UNITED STATES PATENT AND TRADEMARK OFFICE

APPLICATION NO.	FILING DATE	FIRST NAMED INVENTOR	ATTORNEY DOCKET NO.	CONFIRMATION NO.
09/988,322	11/19/2001	Hiromasa Ishiwata	356202/00	8420

Office Action Summary

DETAILED ACTION

Figure_2

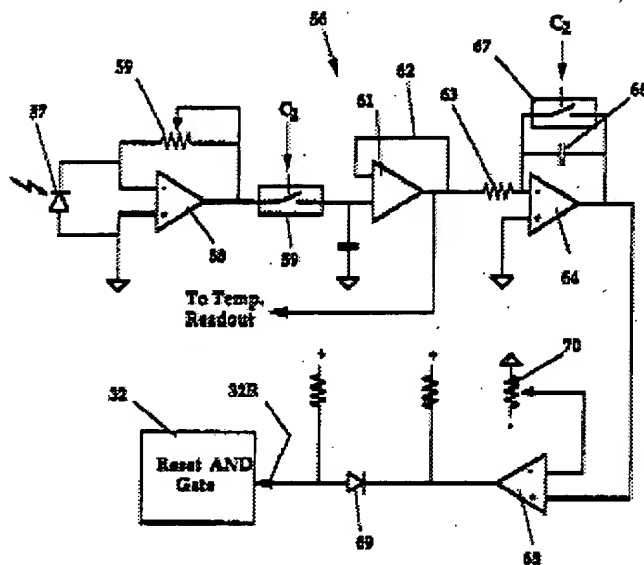
Regarding to claims 1,2,8 and 9, Rink disclosed in fig. 2 a control circuit for laser diode, comprising: an amplifier circuit (64) producing at an output terminal and feedback voltage that is indicative of an optical power via PD (57) generated by laser

diode (not shown) in response to a driving current flowing there through; a driving circuit responding to output voltage to control driving current so as to make voltage difference small; a second amplifier circuit (61) producing at a second output terminal. (See Fig. below). It is inherent that amplifier circuit driving output terminal with a first time constant during a steady operation (created by two switch C2) and with second time second time constant because, when switch(67) is off (open) the gain the operation amplifier (66) is determined by the resistor (63) and capacitor (66), the RC operating to suppress overshoot and/or undershoot of the signal, thus amplifier (64) drives the terminal with a first time constant. When switch (67) is on (close) and switch (59) open then the operation of amplifier (64) functions as a voltage follower in spite of the resistor (63) and capacitor (66). Thus, the amplifier 64 drives with a second time constant that is smaller the first time constant. (See Fig. below);

Regarding to claim 3, and 10 Rink discloses at least one of first and second amplifier circuit includes an operational amplifier (64 and 61), a capacitor (66) coupled between output and input ends of operation amplifier and first switch (67) coupled in parallel to capacitor (66) (See column 6, line 28 – 53 and Fig. below)

Figure_3

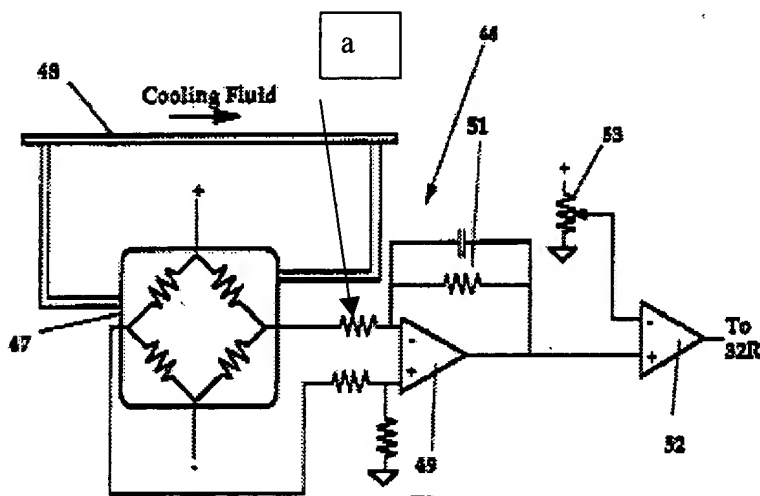
Regarding to claim 22, Rink discloses amplifier (49) circuit further a first resistor (a), a second resistor (51) coupled in parallel to capacitor (See fig. below).
